**Re: *Reliability and Resource Adequacy Study Review – Design Review for L'Anse au Diable and Dowden's Point Grounding Stations***

## **L'Anse au Diable Breakwater Rehabilitation Design Brief**

# L'ANSE AU DIABLE PHASE 2 GROUNDING STATION BREAKWATER DESIGN RE-EVALUATION REHABILITATION

Figure Design Cross Section D-D [5]

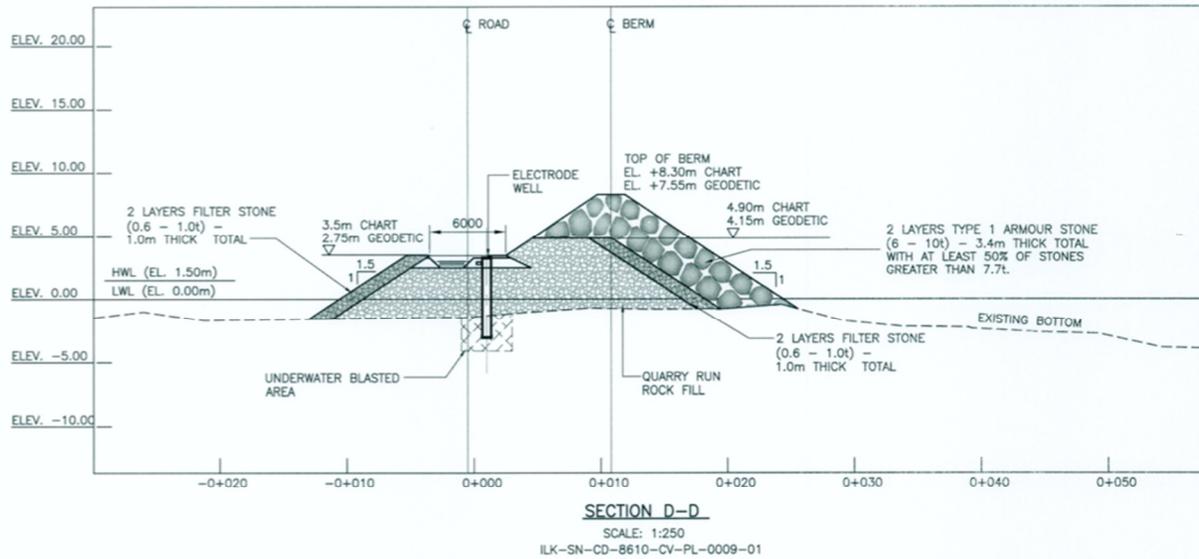
Design documents include a site overview as well as cross sections at various points along the breakwater. Elevations on the design drawings include height for core, filter, and armor stones; as-built elevations are to be as close as possible to these elevations as these elevations are the determined heights for the breakwater to resist wave action.

When reviewing as-built elevations it appears that numerous points along the breakwater have lower than design elevations. The low elevations are not limited to a certain layer but are present in the core, filter, and armor stones.

Station - Cross Section	Armor		Filter		Core Seaward		Core Landward	
	Design	Actual	Design	Actual	Design	Actual	Design	Actual
0+050 - A-A	7.55	7.75	4.15	4.50	4.15	4.25	-	-
0+075	7.55	7.75	4.15	4.50	4.15	4.00	-	-
0+125 - B-B	7.55	7.75	4.15	4.70	4.15	4.00	2.75	2.50
0+175 - C-C	7.55	7.75	4.15	3.95	4.15	4.10	2.75	2.75
0+225 - D-D	7.55	7.80	4.15	3.20	4.15	4.10	2.75	2.60
0+275 - E-E	7.55	7.20	4.15	4.5	4.15	4.15	2.75	2.60
